New design C3 SRTTs Additional Explanations

update of GRBP-78-28e-Rev.1

New C3 SRTT Design – Snow performance

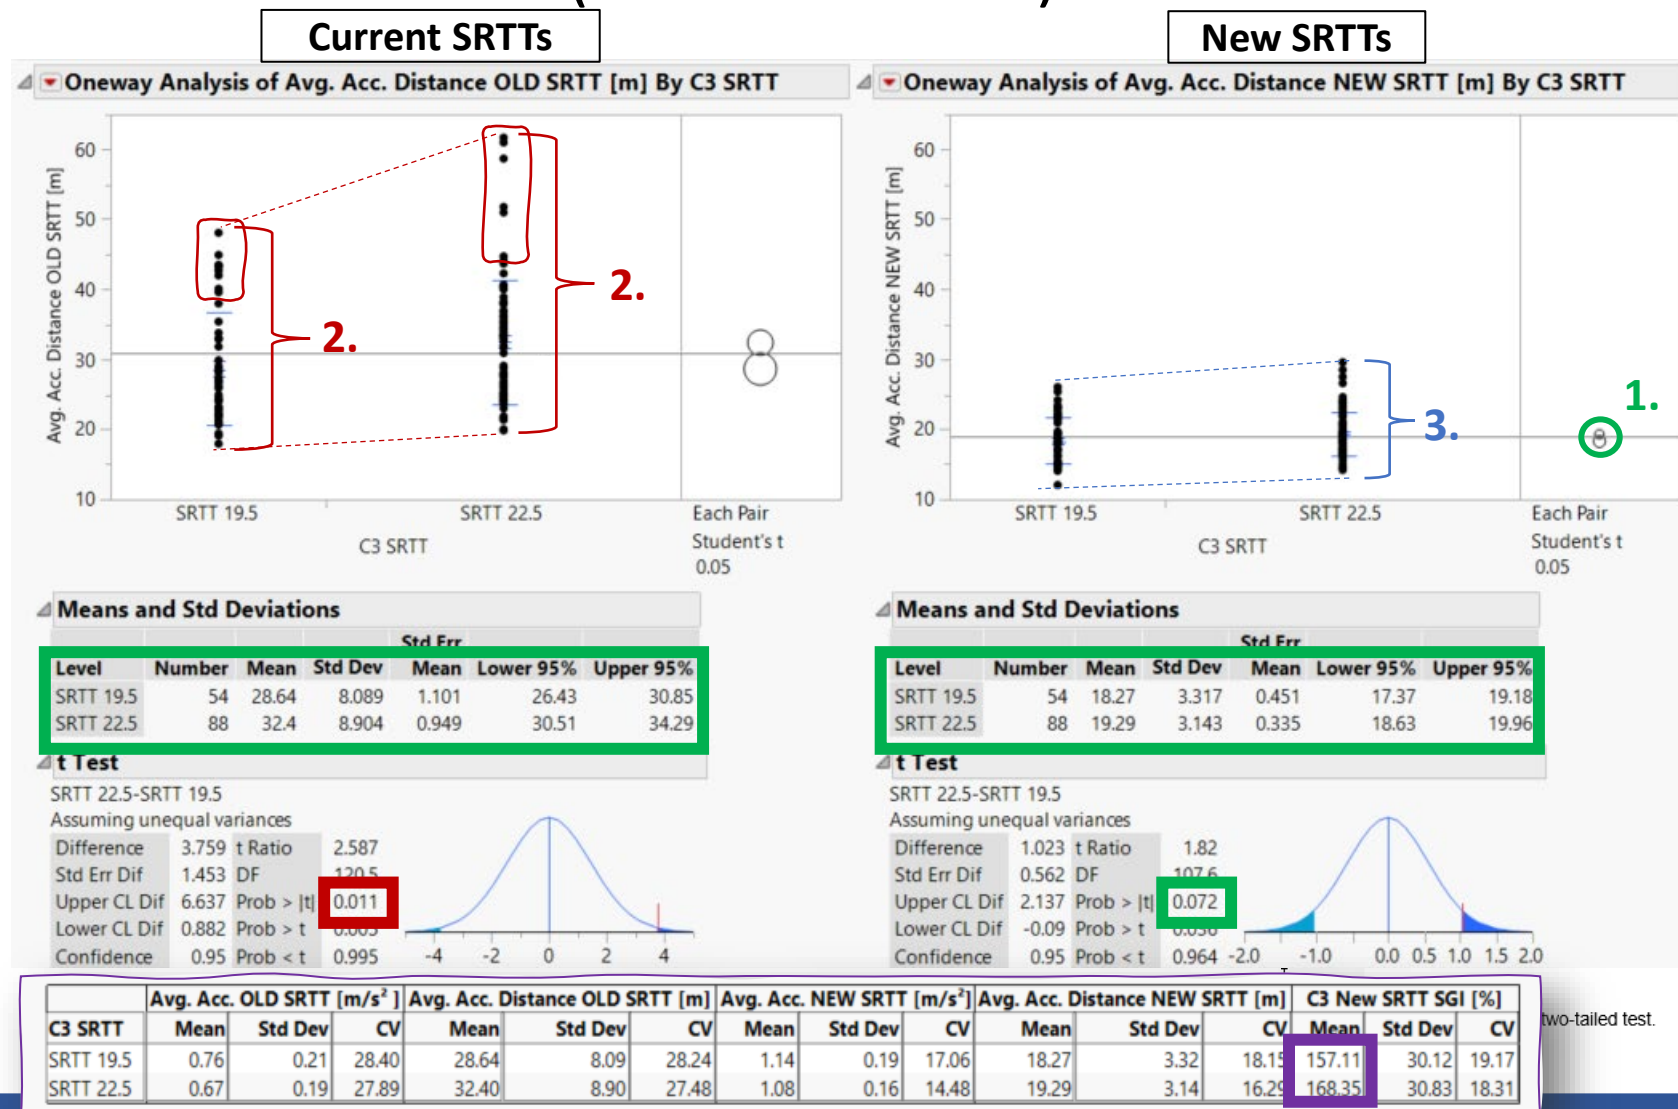
Rib design of the tread pattern of current C3 SRTTs with limited snow performance capabilities

→ High performance variation depending on the track surface conditions during testing

- high performance variations in the evaluation of candidate tyres
- poor correlation between different test providers and/or proving grounds

Need to improve reproducibility of the Snow Grip test results (i.e., reduce the uncertainty of the test) **while not deteriorating the Wet Grip reproducibility**

Interchangeability of the 2 C3 SRTTs – Vehicle method

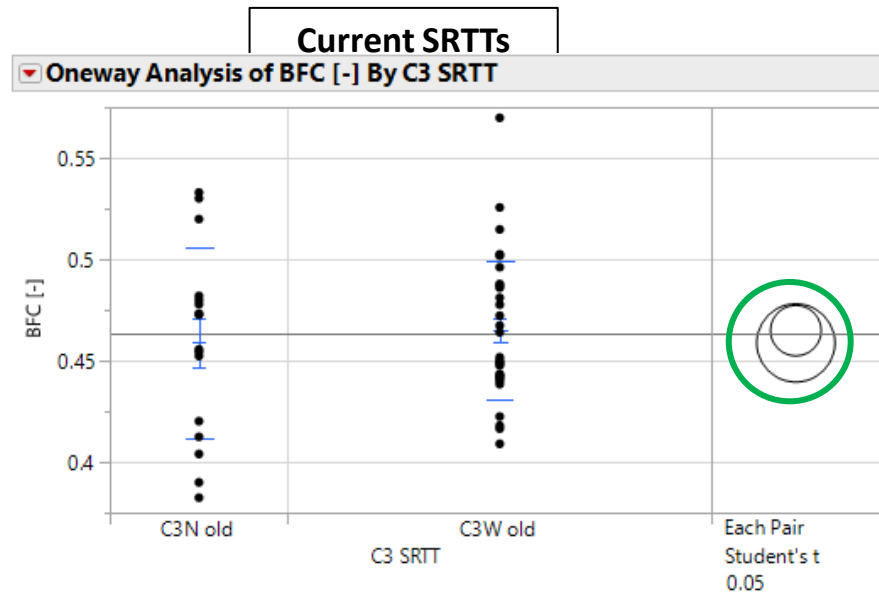
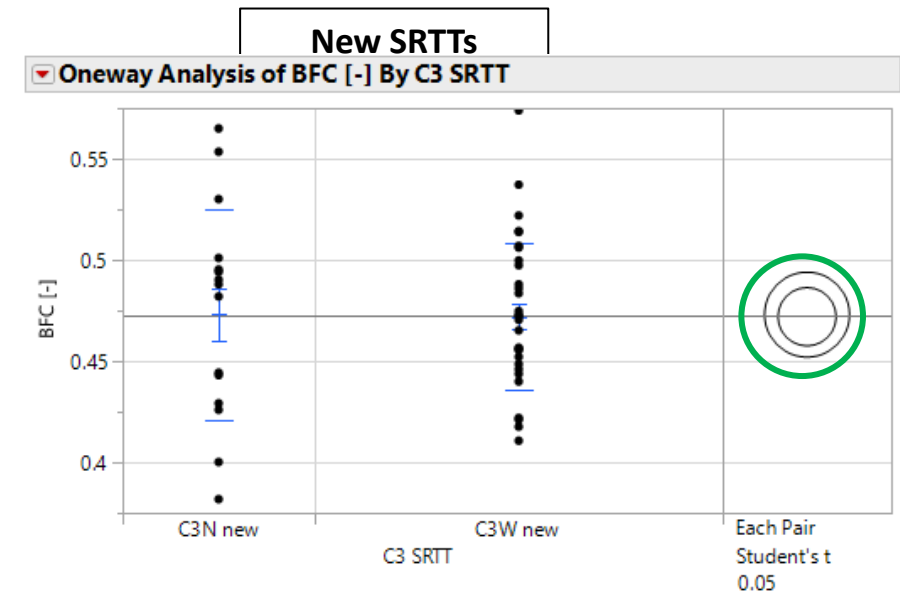
P-value > 0.05 → On average the difference between C3N & C3W (both Current & New) is not statistically significant.

Interchangeability of the 2 C3 SRTTs – Trailer method

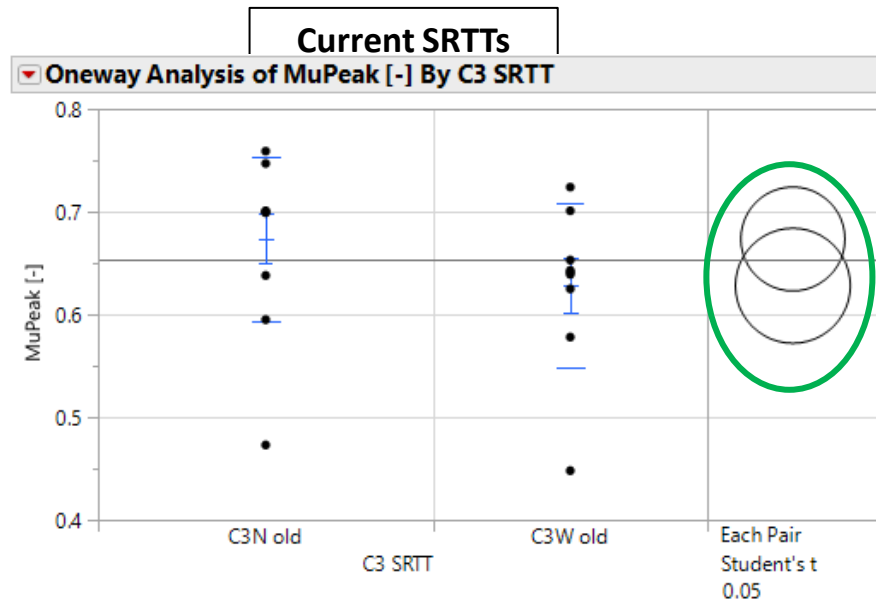
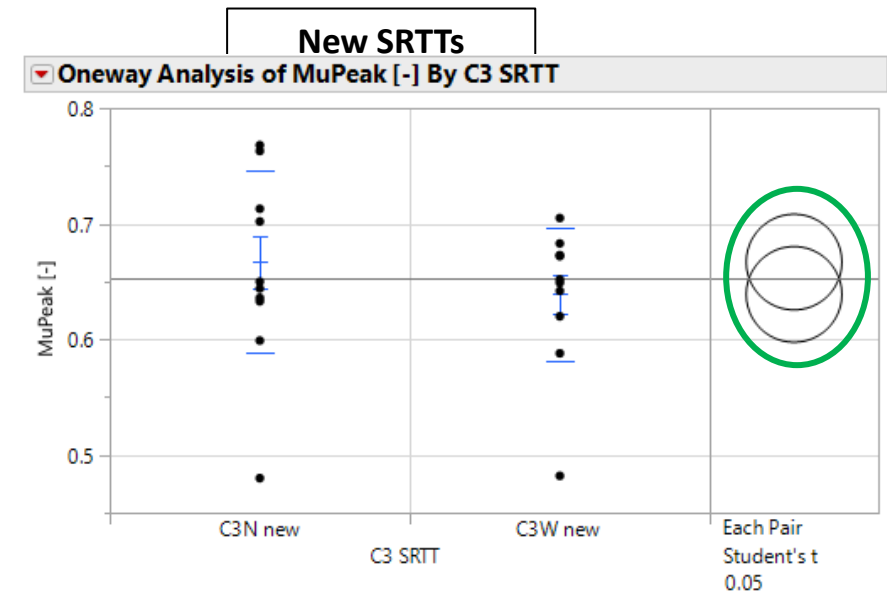
P-value > 0.05 → On average the difference between C3N & C3W (both Current & New) is not statistically significant.

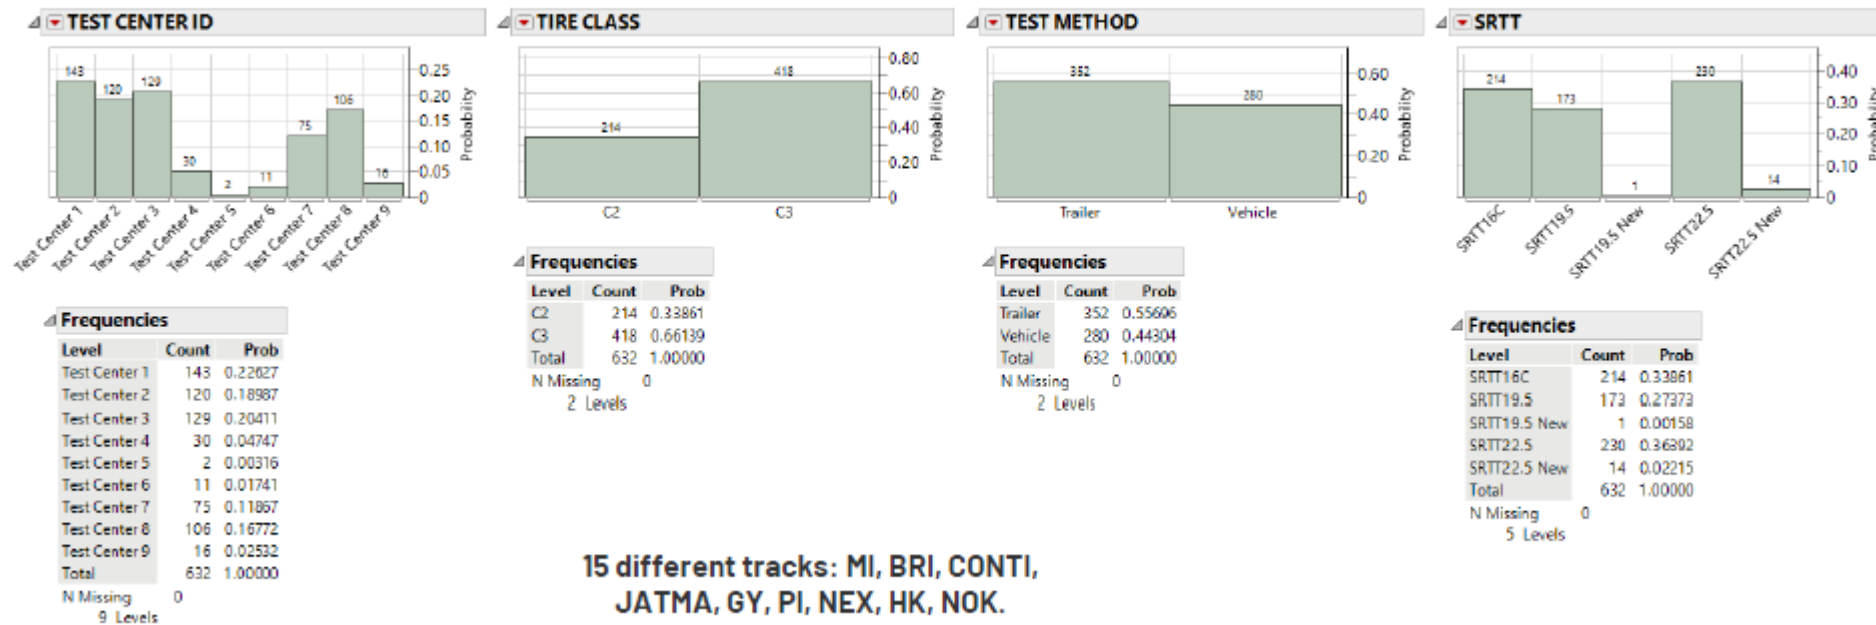
This provision is operationally complex and not effective

- **Requires to drive a C1 trailer fitting the C1 SRTT on C2/C3 tracks**
- **Does not allow a contextual check of the track during the test session.**

As anticipated by the informal document GRBP-78-28-Rev.1, ETRTO investigated the **possibility to characterize and validate the tracks using the same method (i.e., vehicle or trailer) and the same reference tyres (SRTT16C, SRTT19.5 or SRTT22.5) used in the evaluation of the candidate tyre**, using the same approach as C1 tyres wet grip index procedures.
